**NSLPP MEETING HELD ON 07/09/2022****SECTION 4.55 APPLICATION REPORT****Attachments:**

ADDRESS/WARD: 372 Military Road, Cremorne**APPLICATION No:** D269/21/2**PROPOSAL:** Section 4.55(2) application seeking modifications to Development Consent (D269/21) including various amendments to the deferred commencement approval for a five (5) storey mixed use development.**PLANS REF:**

OWNER: Canopy Investment Holding Pty Ltd**APPLICANT:** Platino Properties Pty Ltd**AUTHOR:** Robin Tse, Senior Assessment Officer**DATE OF REPORT:** 30 August 2022**DATE LODGED:** 21 June 2022**RECOMMENDATION:** Approval (In-part)

Figure 1: Proposed modified southern (Military Road) elevation.

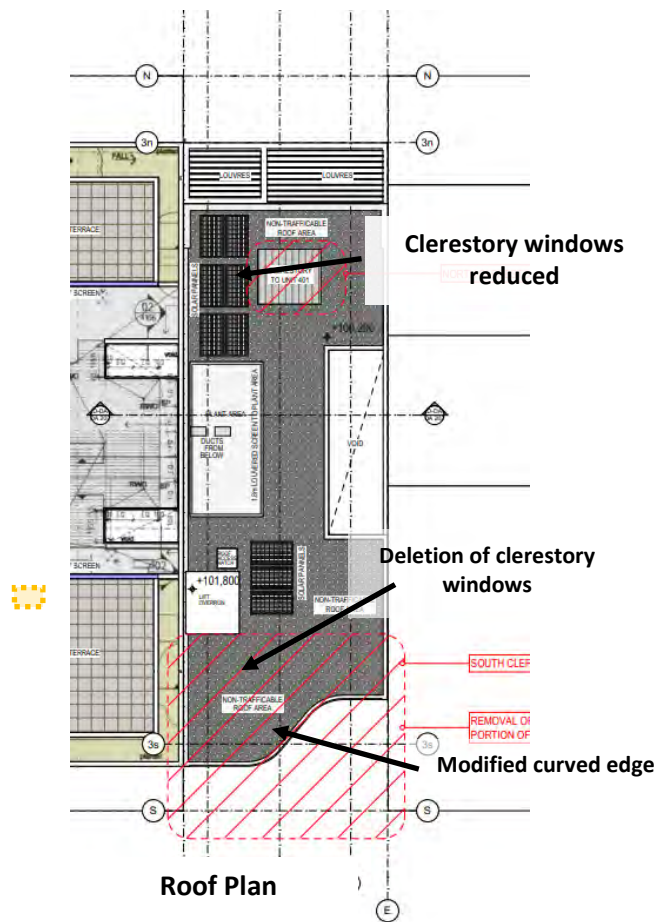
The proposed design modifications to the southern (Military Road) façade on Levels 3 and 4 do not provide a respectful transition in building heights, built forms, building bulk and scale between the subject site and the heritage listed Orpheum Theatre. Therefore, this aspect of the subject Section 4.55 application is not supported and is recommended for deletion from the modification plans.

*The setback of less than 8m at Level 4 from the Military Road boundary creates a more imposing outcome on the setting of the heritage item and does not enhance the outcome as required in the original deferred commencement approval. As such, the proposed modifications cancel out the benefits of the deferred commencement outcome of appropriate transitional heights between the group of buildings at Nos. 358-398 Military Road, including the subject site, and the Orpheum Theatre building. As such, the s4.55 application is contrary to NDCP 2013 Part B: s13.4 and is **not supported**.*

The proposed modified design as shown in **Figure 11** does not adequately address the heritage concerns as indicated in the comments from Council's Conservation Planner above because Level 4 of the proposed modified development would still be highly visible and imposing as seen from Military Road. In addition, the curved glass and eave lines on the southern elevation of Levels 3 and 4 above the podium are contrary to the primarily angular built form of the southern façade. Therefore, the proposed design changes to the Level 3 southern façade are not supported by Council Officers.

Figure 12: Proposed development and LEP building height limit

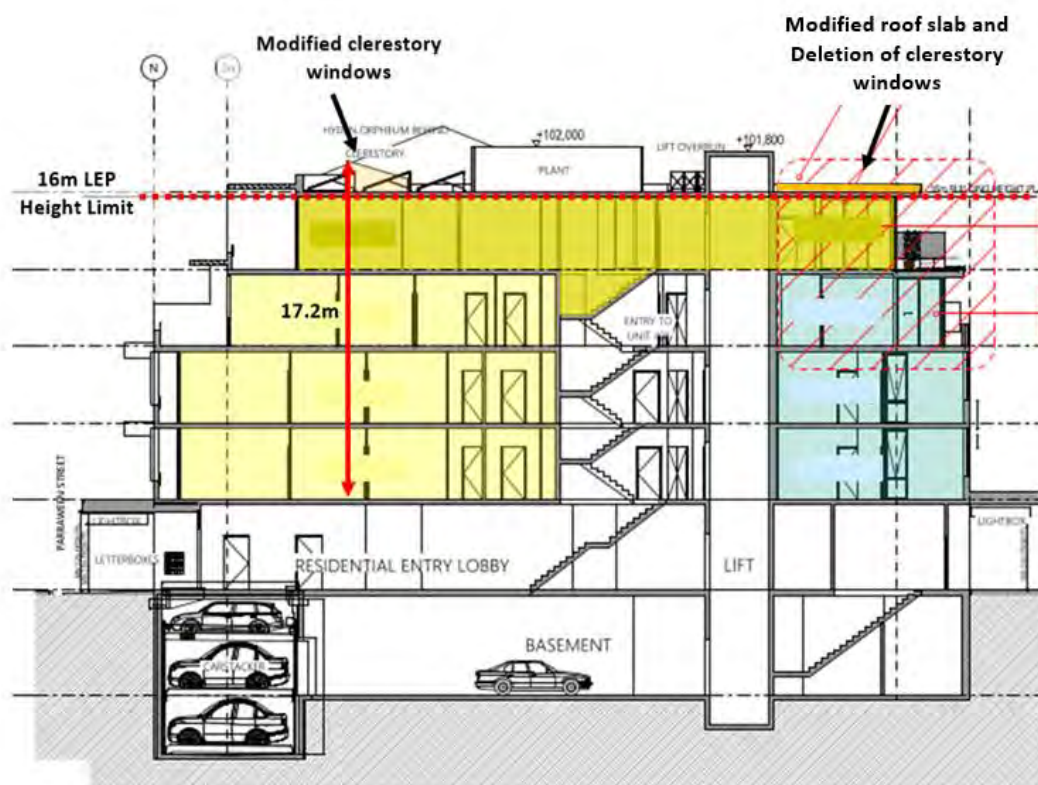
However, the proposed revision of the design for the clerestory windows on the roof level and the modified roof slab on the southern side of the proposed mixed use building would cause further non-compliance with the LEP 16m height limit as illustrated below:

The modified building elements in breach of the LEP maximum height limit would be the revised clerestory windows on the northern side of the roof and the modified roof slab on the southern side of the building.

Notwithstanding the above, no objection is raised to the modifications to the clerestory windows over the LEP height limit because this aspect of the proposal would have no material impacts on neighbouring properties and the locality in terms of the built forms within the locality and the amenity of the surrounding properties.

THIRD FLOOR 1:100

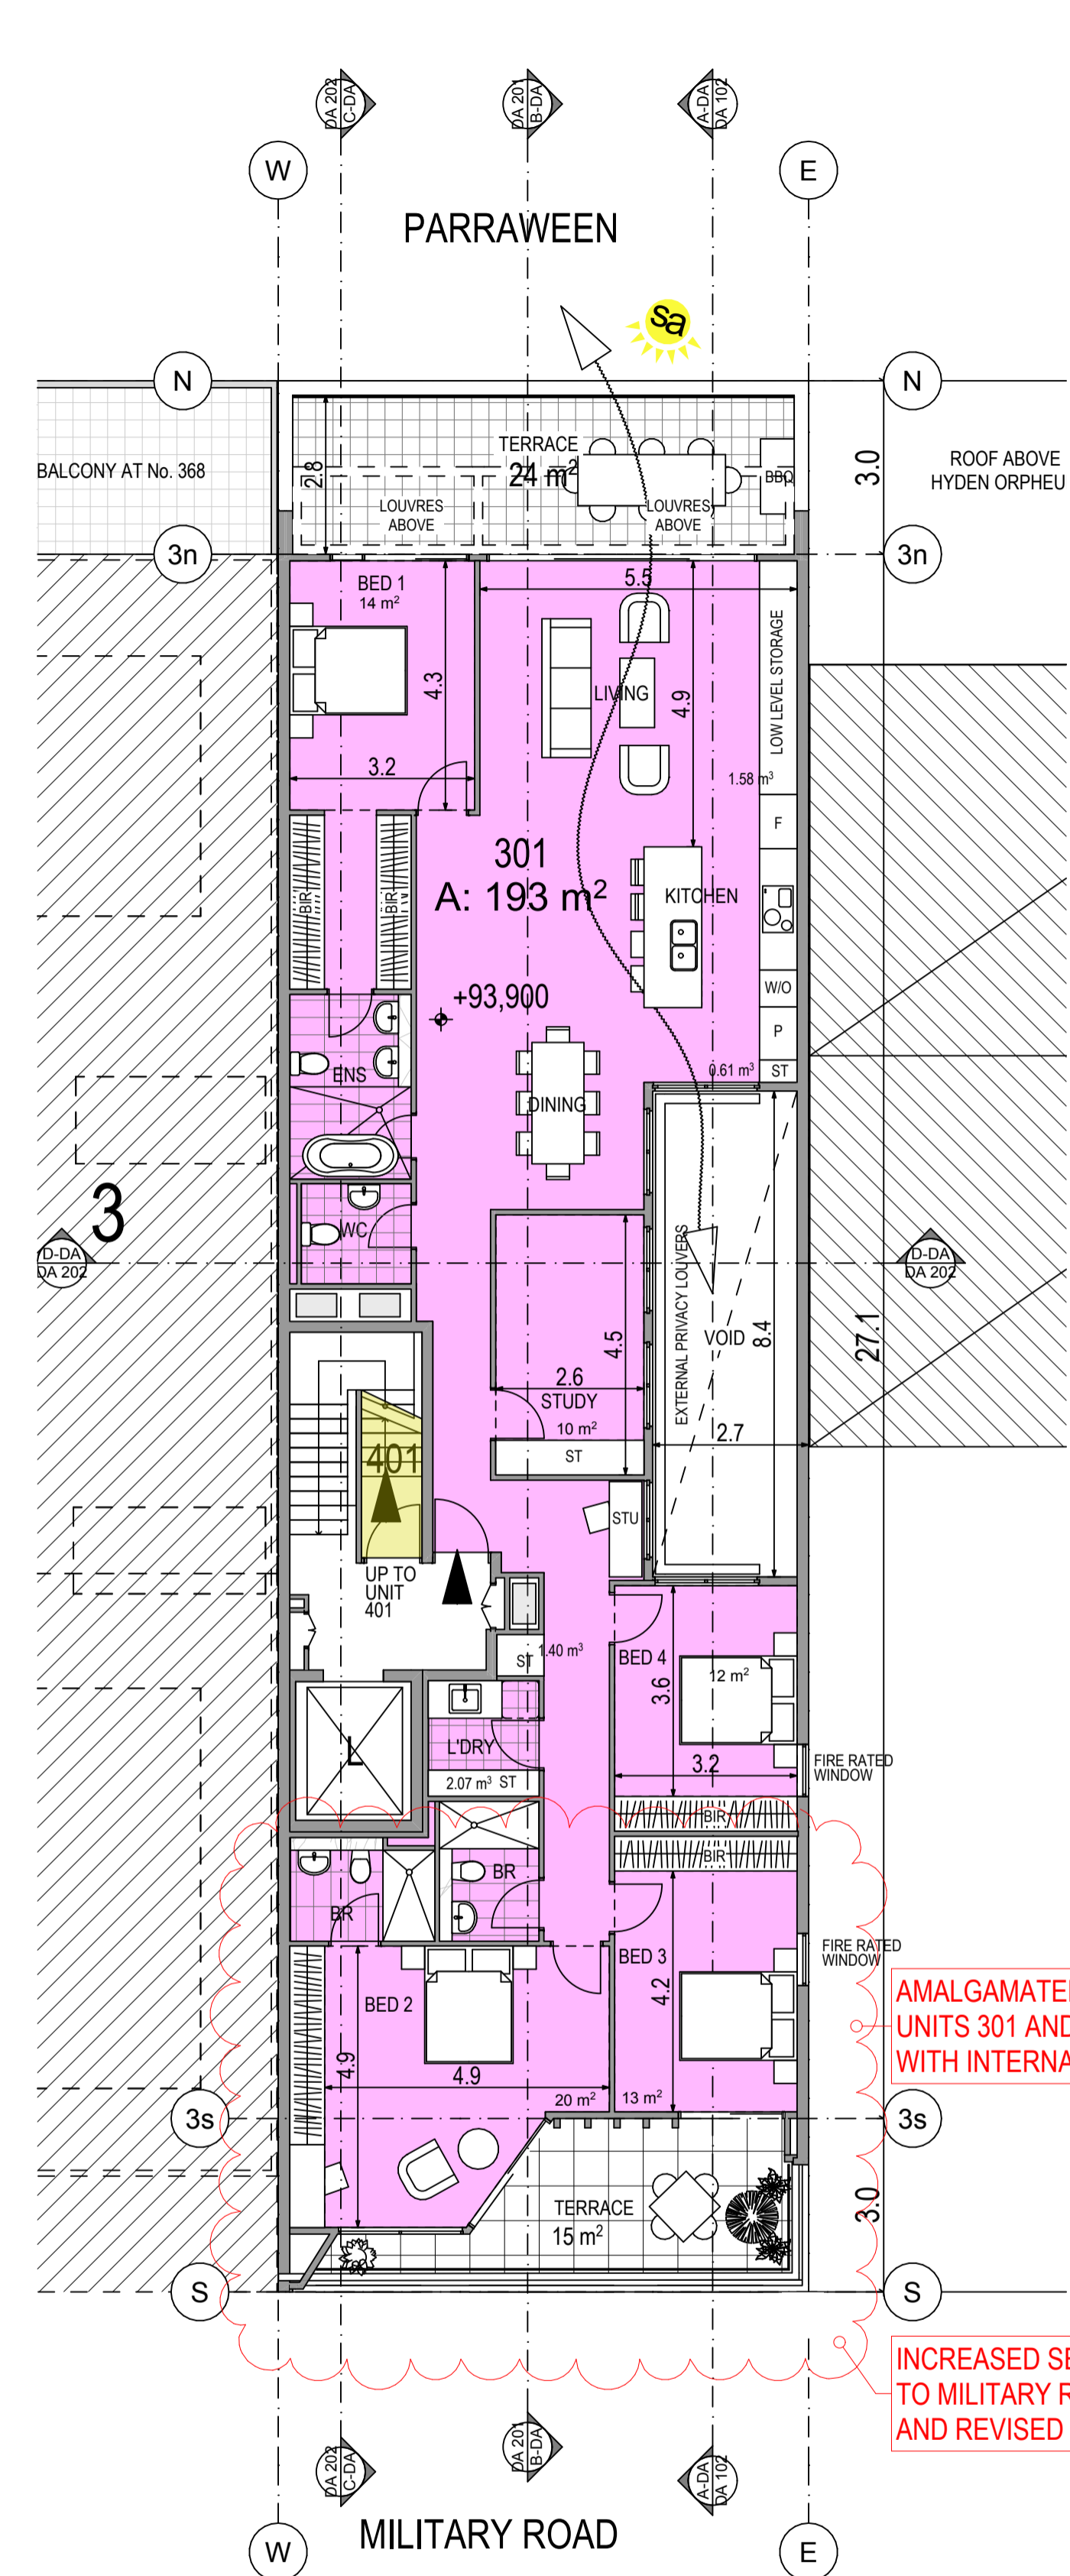
However, it is considered that the amalgamated apartment should be accommodated within the Level 3 building envelope of the original design because the unsympathetic curved built form on the southern elevation would have a detrimental impact on the significance of the heritage listed Orpheum Theatre. It is therefore recommended that **Condition AA1** be modified to include an additional requirement that the amalgamated apartment on Level 3 shall be accommodated within the Level 3 building envelope as proposed the original DA.

AMALGAMATED
UNITS 301 AND 302
WITH INTERNAL LAYOUT CHANGE
